FROM THE OFFICE OF THE CITY MANAGER

Subject: City Council Agenda Questions & Answers – 03.20.2023

Agenda Item E-01 PUBLIC HEARING - PRELIMINARY SITE PLAN REVIEW (FILE NUMBER SP2022-0027) - PROPOSED ESTATES AT ECKFORD (ONE FAMILY RESIDENTIAL CLUSTER), SOUTH SIDE OF ECKFORD, WEST OF ROCHESTER, SECTION 15, CURRENTLY ZONED R-1C (ONE FAMILY RESIDENTIAL) DISTRICT

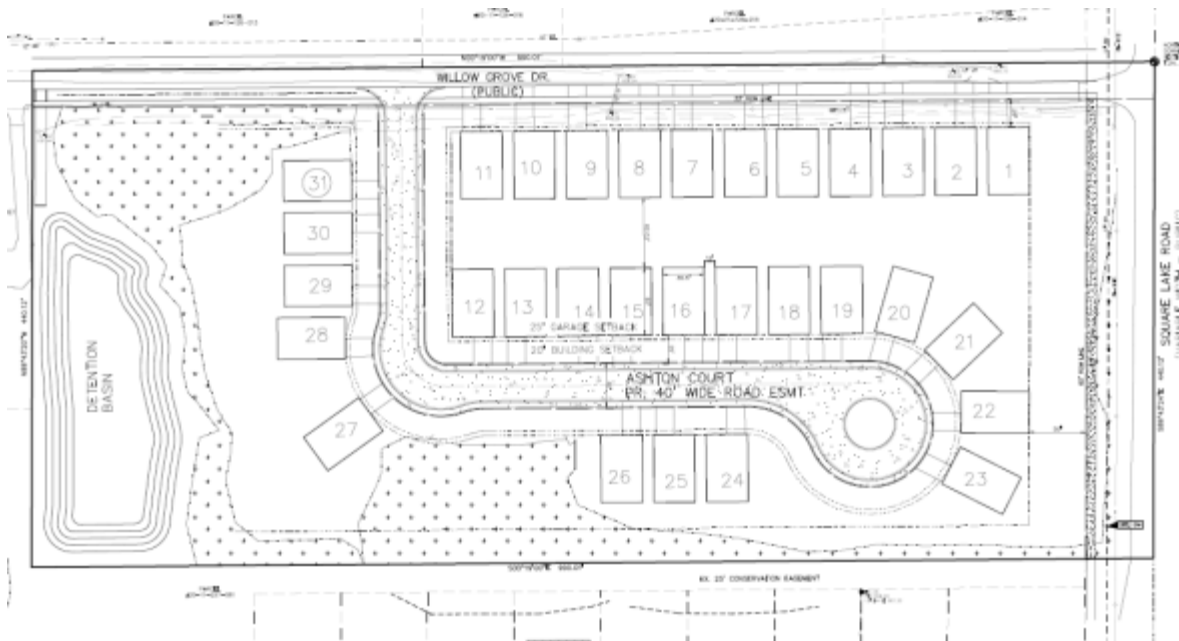
- Have there been any other cluster developments approved in Troy with driveways off of or fronting on existing roads - such as the 9 homes on Eckford and the one home on Tallman (as opposed to being situated off of new internal drives constructed by the applicant on the site)?

Eckford Woods (across Eckford to the north) has 2 homes with driveways on Eckford.

Willow Grove was approved for 11 units on Willow Grove, out of 31 total units. Note. North (Square Lake Road) is to the right in this drawing.
